SUMMARY REPORT

FIRE SPRINKLER SYSTEM PERFORMANCE BUILDING FIRE

GWINNETT CLEAN & BEAUTIFUL
4300 SATELLITE BOULEVARD
DULUTH, GEORGIA

February 28, 2013

General Area Showing Eddycurrent and Transfer Conveyor

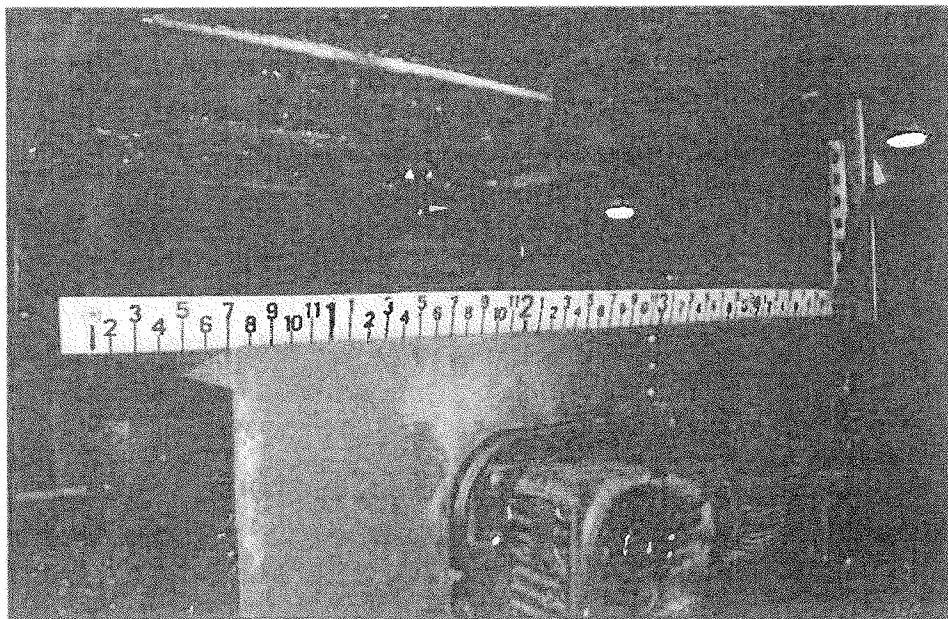
As noted above, the subject fire which initially started in the Eddycurrent spread to an area beneath a nominally 5-foot wide transfer conveyor that traversed the Eddy current feed conveyor. This created an obstructed area that prevented ceiling sprinkler discharge from reaching the hazard area below the transfer conveyor. Since the transfer conveyor was greater than 4-feet wide, sprinklers were required in this area per NFPA 13. However, there were no such sprinklers were installed in this area at the time of fire. Due to these missing sprinklers, the fire was allowed to continue to burn/spread within the concealed areas causing severe damage to the transfer belt and related equipment.

Based on information currently available and my analysis to date, the lack of fire sprinklers under the nominal 5-foot wide transfer conveyor near the Eddycurrent as required by NFPA 13, the scope of work narrative and D&C's proposal was the principal cause which allowed the fire to spread from the Eddycurrent into the concealed area created by the transfer belt allowing extensive damage to the transfer belt and surrounding equipment. If fire sprinklers had been installed to protect the obstructed areas as required by applicable codes and the scope of work, it is likely that the damage resulting from this fire would have been limited to the Eddycurrent and its associated feed belt.
